PROJECT		TITLE		SIZE		STATUS	
3-9 Grosvenor Road, Wrexham, LL11 1DB		Proposed Building Elevations Sheet 2		A1		CONSTRUCTION	
PROJECT NO. 1449				DRAWING NO. L021 K			
DRAWN BY AJS				CHECKED AJS			
DATE Jul 2015				SCALE (1:1)

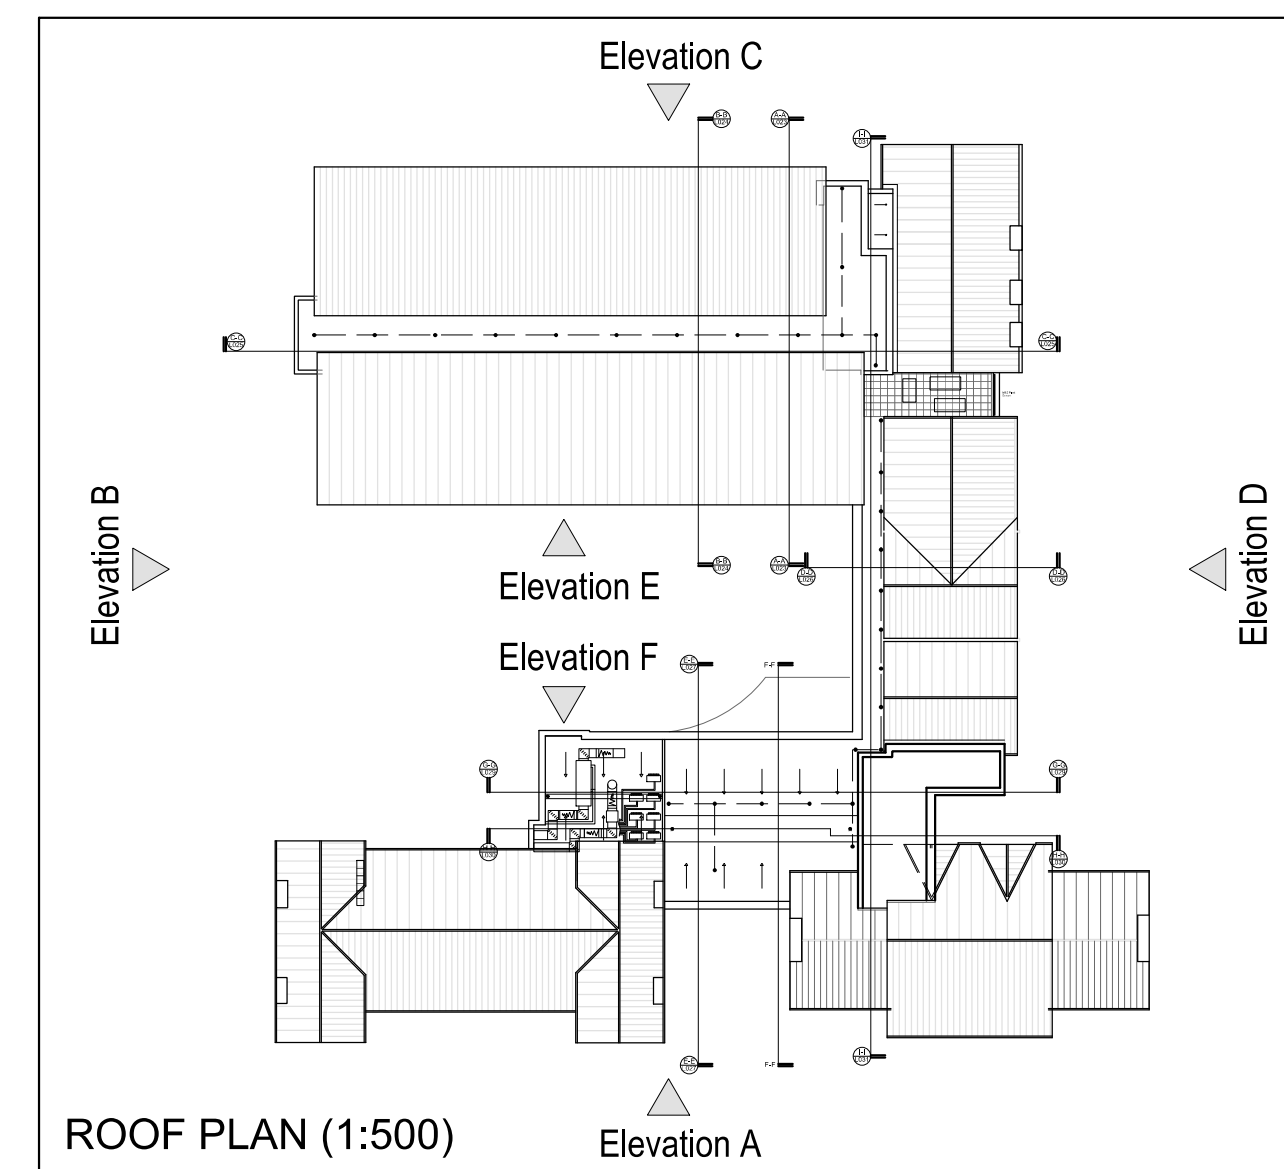
- Window cills lifted up due to proximity of carparking spaces

Rev K	Glazing bars to timber windows removed as per conservation officers approval	Jul 17	AJS
Rev J	WS.14 amended	Jun 17	JJ
Rev H	Cill heights increased to 825mm affl to Windows at 1st flr elevation D	Apr 17	AJS
Rev G	Window amended to suit manufacturers details, Feb 17	JJ	
	RWP locations identified on elevation D-D

Rev F	Status amended, notes amended	Jan 17	JJ
Rev E	CWL.G.04 revised as per km request	Jan 17	JJ
Rev D	CWL.G.05 Added to elevations	Dec 16	
Rev C	AOV location identified	Jun 16	
Rev B	Zinc finish amended	Dec 15	
Rev A	Drawing amended as highlighted	Oct 15
